Product Change Notification – 2025/14

Product Line:	XLR Chassis	Part No:	NC3F*
---------------	--------------------	----------	--------------

Piece Part:	Chassis	Part No:	1013987
-------------	---------	----------	---------

Engineering Change Request:	2024-1221	Date:	25 Sep 2025
-----------------------------	-----------	-------	-------------

OLD

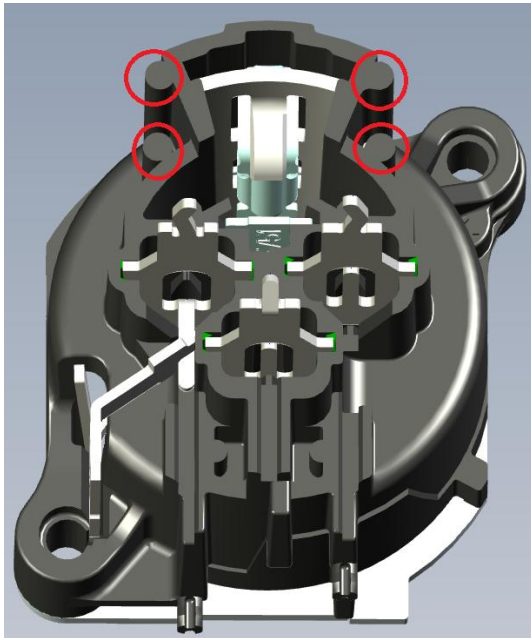
Comments:	The ribs on the chassis have been removed
-----------	---

As part of continuous improvement, we have invested in a new injection molding tool. During the manufacturing process with the old injection molding tool, additional ribs were present on the rear side of the chassis. These ribs had no function in the end product, but were necessary for the molding process with the old tool. With the new tool, these ribs are no longer needed and have been removed.

- The removed ribs had no functional relevance for the end product.
- Mechanical, electrical, and dimensional specifications remain unchanged.
- No impact on product performance, quality, or reliability.
